***NEWLEAF COMMUNITIES
PROJECT BONNYRIGG***

***MODIFICATION REQUEST:
Modifications to amend the Concept Plan***

MP06_0046 MOD 3

Director-General's
Environmental Assessment Report
Section 75W of the
Environmental Planning and Assessment Act 1979

Figure 5: Approved and proposed modified layout for Stage 3 (Green) (Source: Urbis)

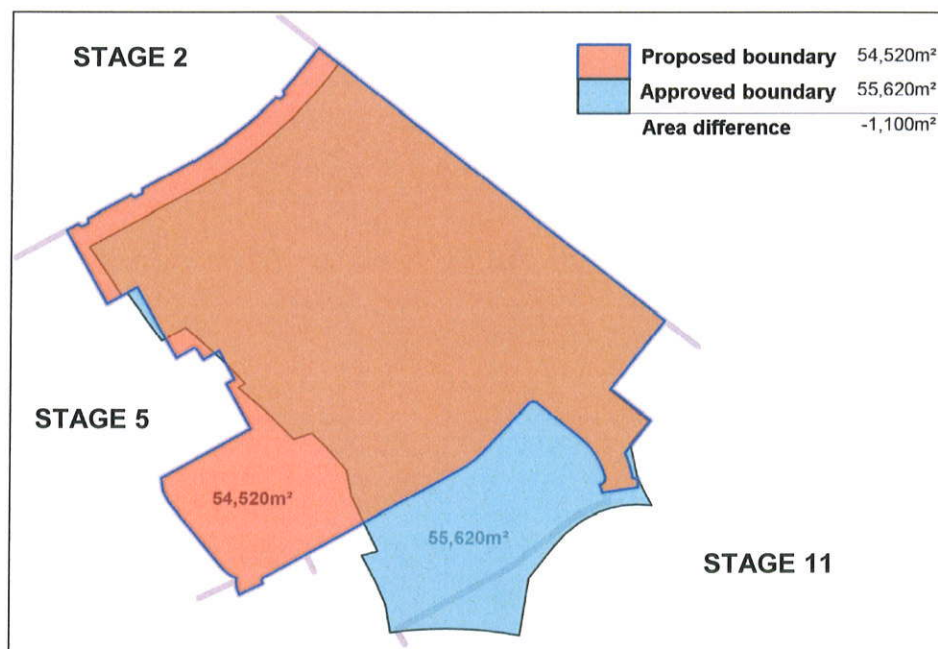
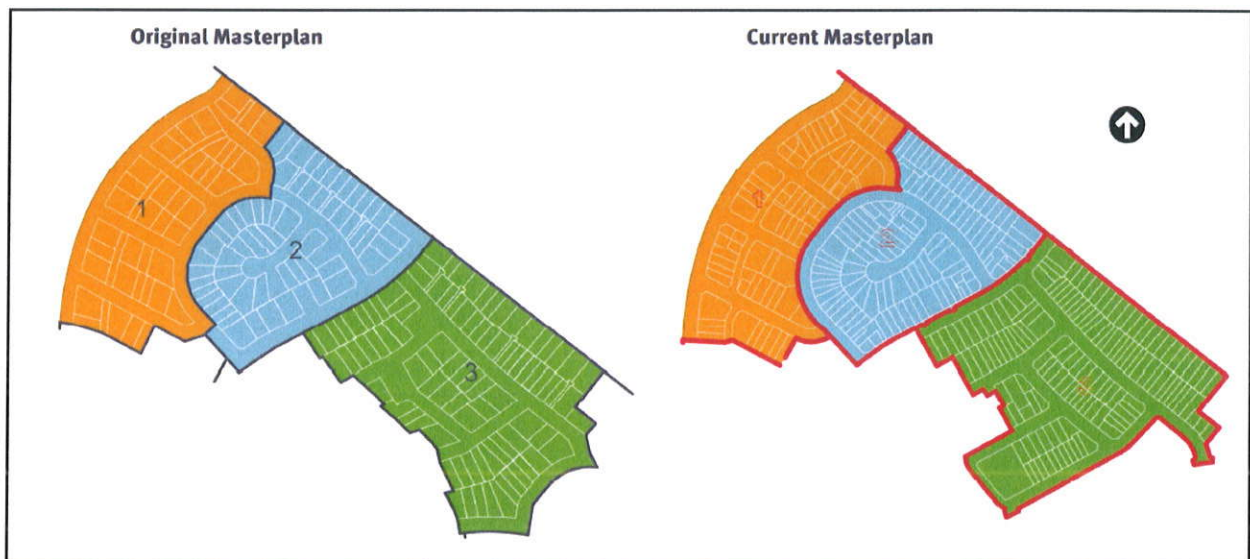
The original approval of the Masterplan was for development of the Bonnyrigg Estate in 18 stages over 13 years. The modification seeks to alter the approved staging boundary of Stage 3 by re-aligning the boundaries and reducing the overall area by 1,100m² as seen in **Figures 4** and **5** below. This will have future impacts on Stage 5 and 11 (refer to **Figure 3**).

Council has not raised an objection to the proposed boundary adjustment and are satisfied that the reduced site area for Stage 3 is not associated with any increase in dwelling yield or dwelling density for Stage 3.

The Department has considered Council's comments and the Proponent's justification in its assessment of the proposed modification and considers that the minor adjustment to the Stage 3 boundary are acceptable given that the overall density (Stages 1-3) complies with the Concept Plan approval.
